Subject: SLICE FLEX Quick-Release Design Upgrade	
Affects: 13000-30550 and 13000-30470	Date: 1 August 2014
Immediate action required: Customer action required upon receipt.	For additional information, contact: support@dtsweb.com or submit a request via support.dtsweb.com

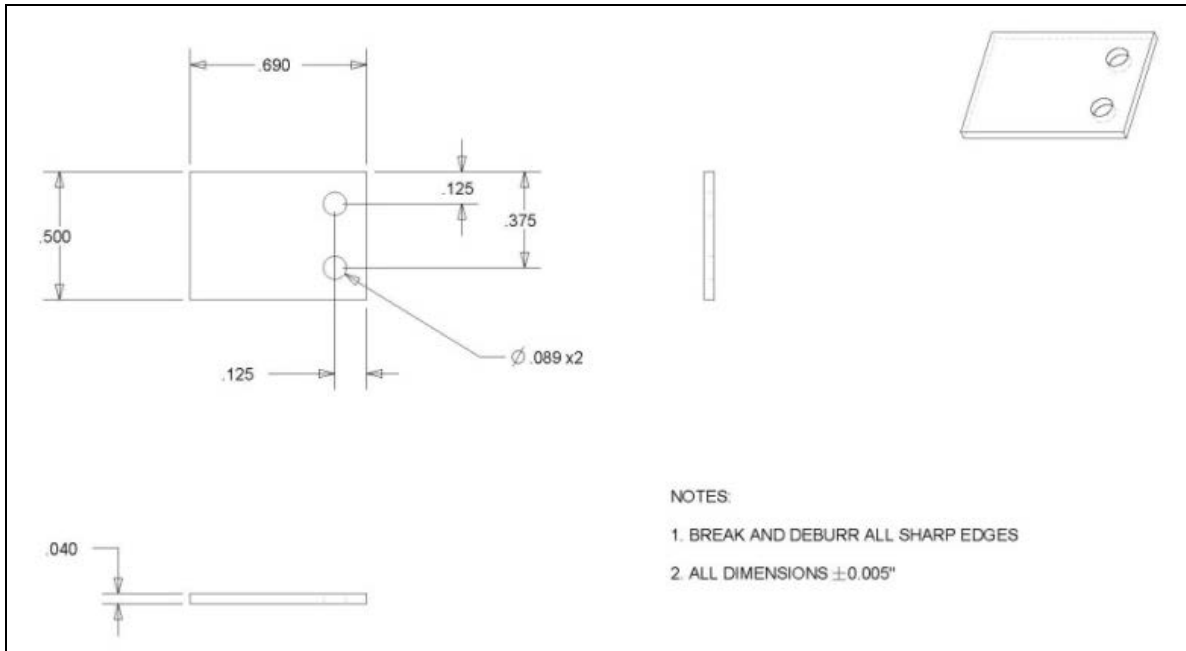
The SLICE FLEX quick-release cable system has been redesigned to address concerns of long-term survivability. Customers ordering the SLICE FLEX quick-release bracket (P/N 13000-30470), will be provided with a spacer that should be incorporated into the mating SLICE FLEX latching chain cable (P/N 13000-30550). This will allow for continued quick-release functionality. The spacer (P/N 89100-17710) provided is shown below.

- 1) Unscrew the FLEX leg locking mechanism from the FLEX latching backshell. Retain the screws (socket cap, 18-8 SS; 2-56 x 1/4") and washers (flat, 18-8 SS; #2, 1/4" OD) for reuse.

- 2) Place the spacer provided on top of the FLEX latching backshell and re-assemble the quick-release portion of the cable using original screws and washers.

- 3) Re-connect with mating cable, and upgrade is complete.
